HWY. No. 2LOCATION Failure of Embankment4 km W of WardsvilleNo of PAGES - 1

**Re: Inspection of Highway 2 Embankment  
4 km West of Wardsville  
Highway 2, District 32, Chatham**

Re: Restoration of Embankment  
Hwy. 2, 4 km West of Wardsville  
Contract No. 32-95-02 (WP 300-92-00)  
District 32, Chatham

Re: Restoration of Embankment (Stn. 14 + 567 to Stn. 14 + 625)  
W.P. 300-92-00, Highway 2, District 32, Chatham

#### AREA OF RESTORATION

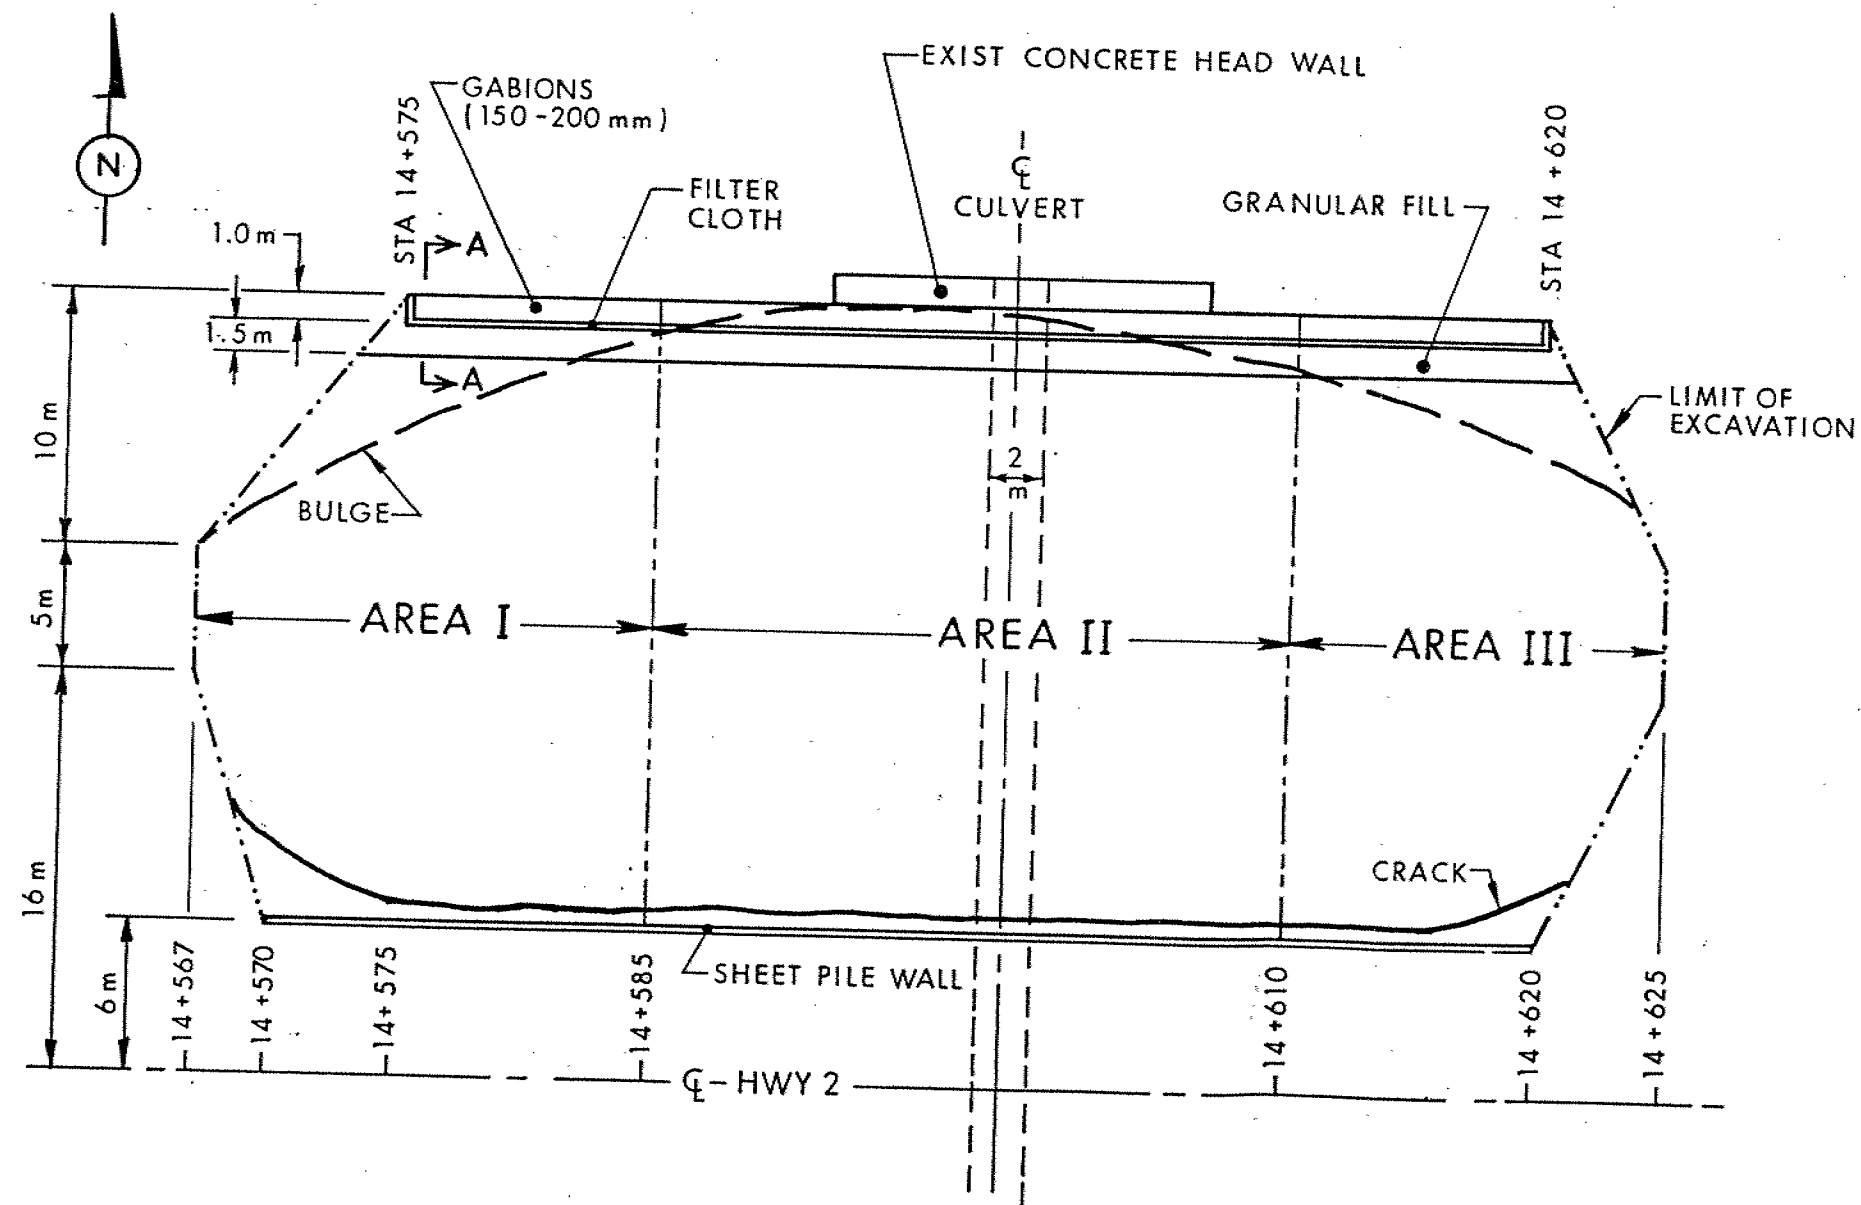
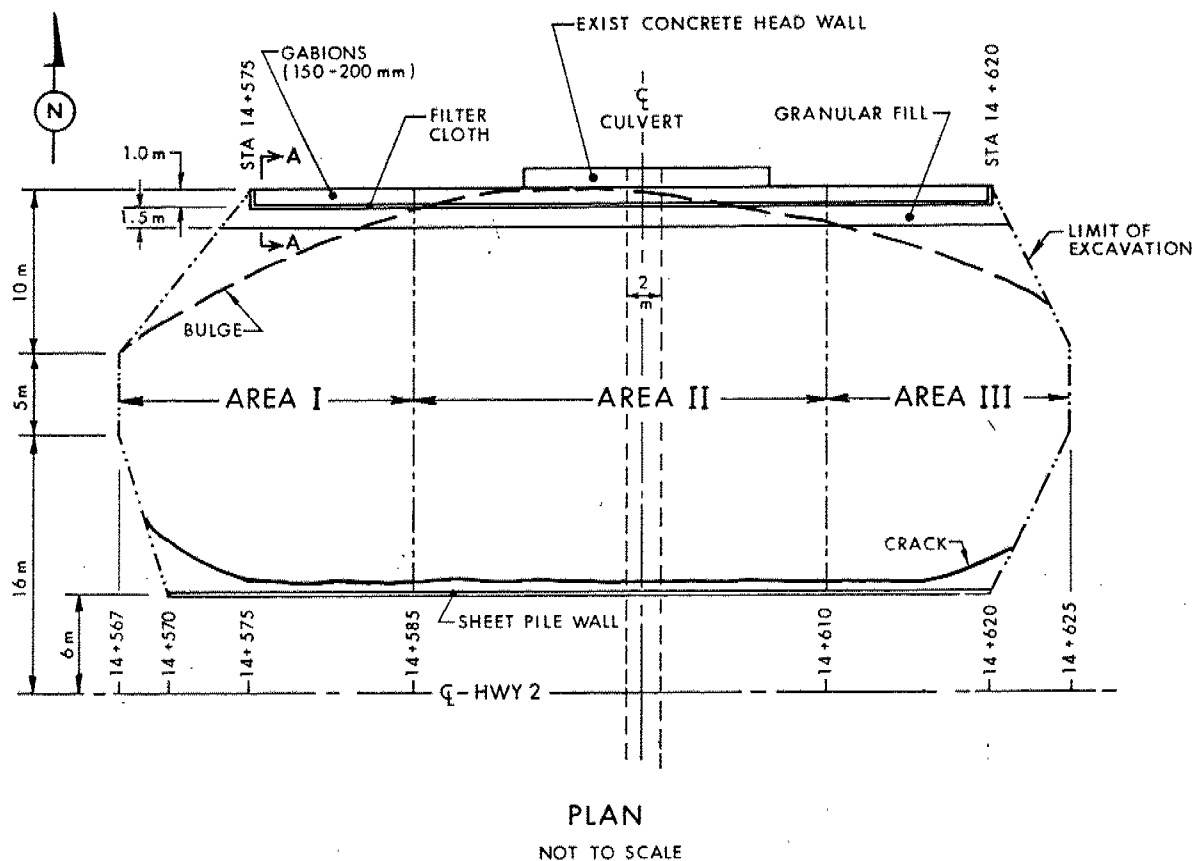
The area of subexcavation as well as details such as location of gabion and sheet pile wall are shown on Figure 1. Benching arrangements are shown on Figures 2, 3 & 4.

- 1) Drive the sheet pile to El. 203 from Stn. 14 + 570 to Stn. 14 + 620
- 2) Provide benching as shown on Sections 14 + 582 for Area I, 14 + 598.5 for Area II and 14 + 615 for Area III
- 3) Remove any spongy or soft areas observed below the bench level specified and backfill with acceptable fill material.
- 4) Place the gabion and filter cloth as shown on Figures 1, 2, 3 & 4.
- 5) Place the fill in layers and compact.

SECTION AT STA 14+582

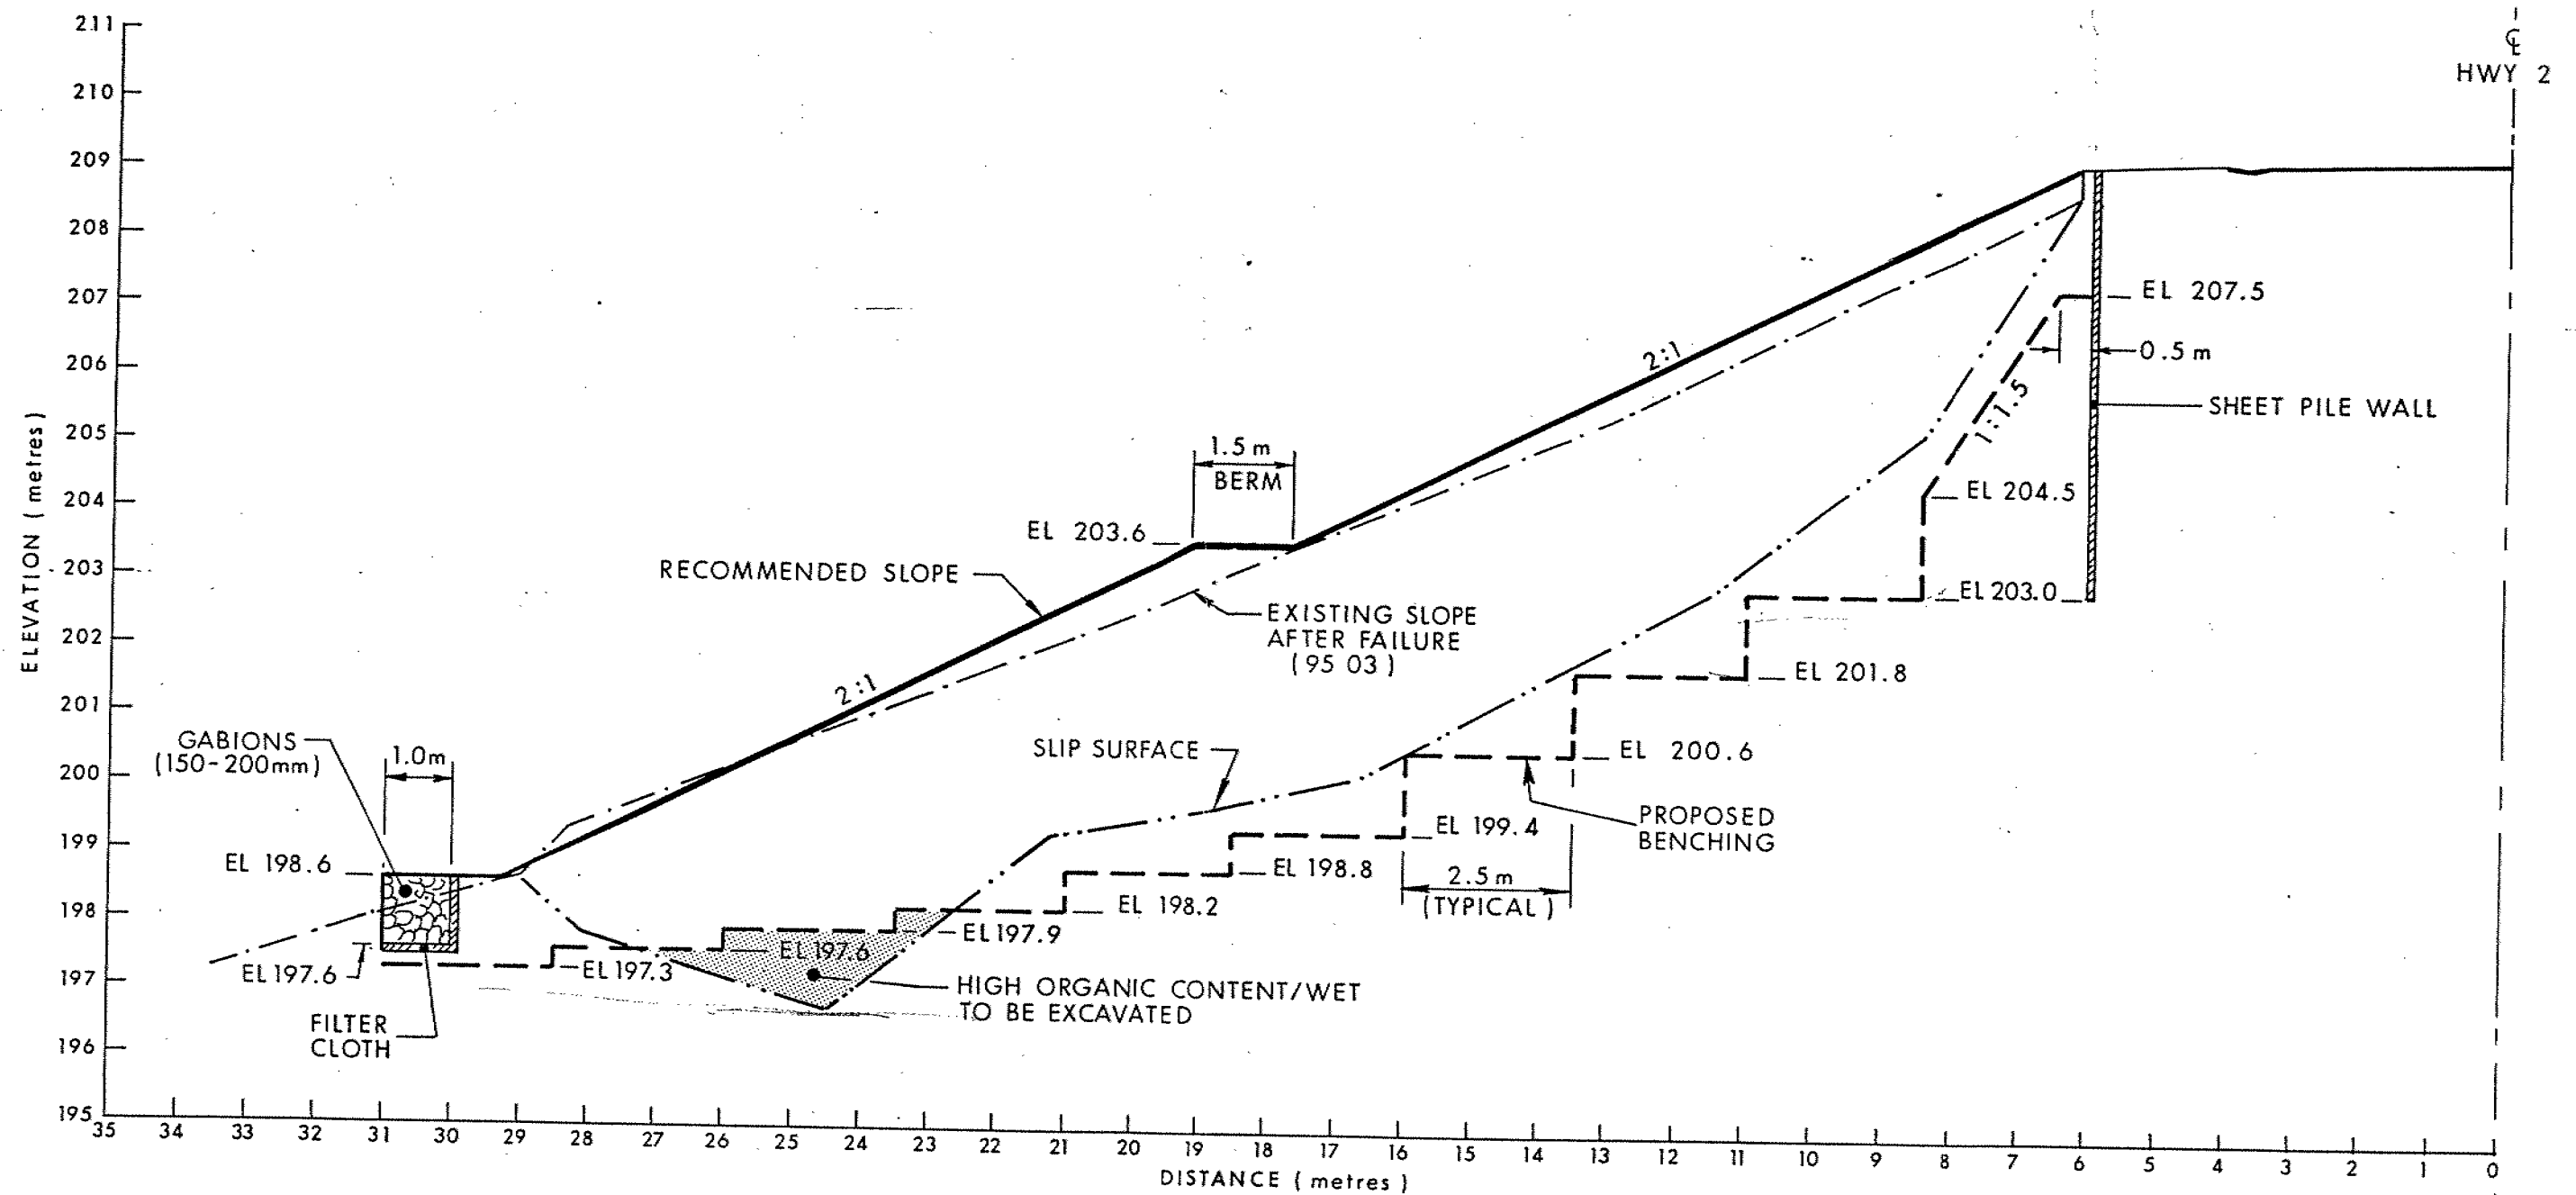
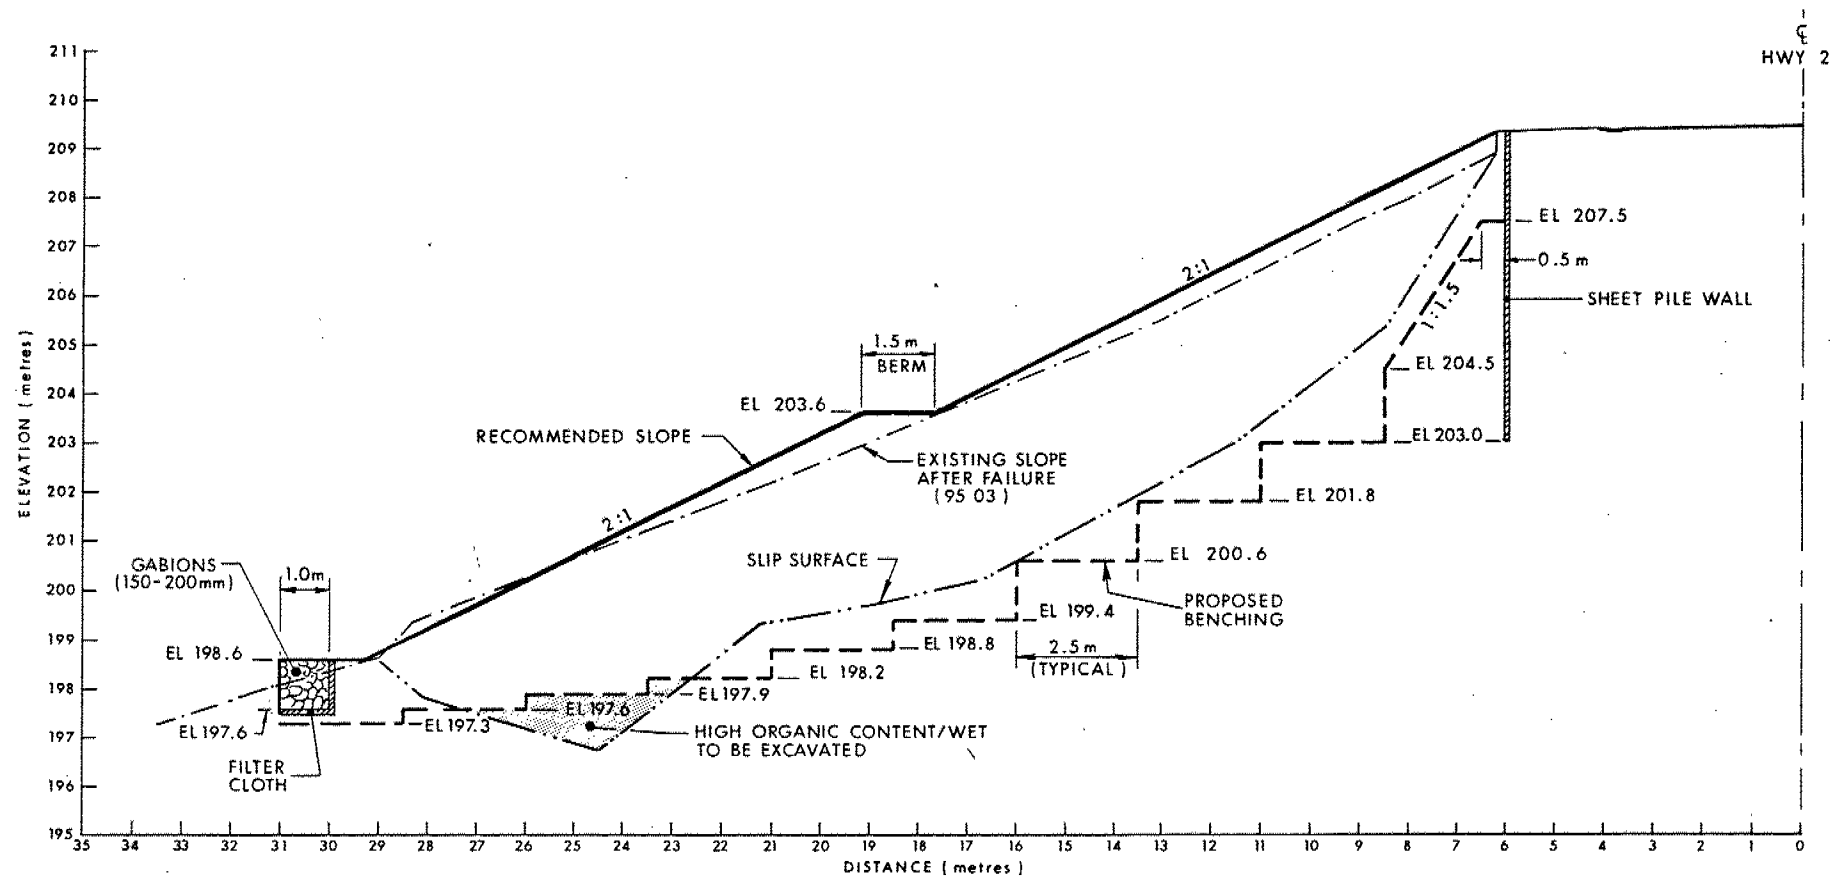
- 1) Are the drawings which accompanied your June 22, 1995 Memo available in digital (AutoCAD) format? If so can they be sent to me by e-mail? *No*
- 2) The granular fill specified on Figure 1 - what type of material should be specified (ie Granular A, Granular B, etc)? What is the lower limit of this material (bottom of gabion or subgrade)? *'Granular B' OK.*
- 3) Figures 3 and 4 show the gabion basket and filter cloth resting on subgrade, Figure 2 shows gabion installation above subgrade. Should figure 2 show the gabion placement on subgrade as well? *This should be as shown in Figure 2*
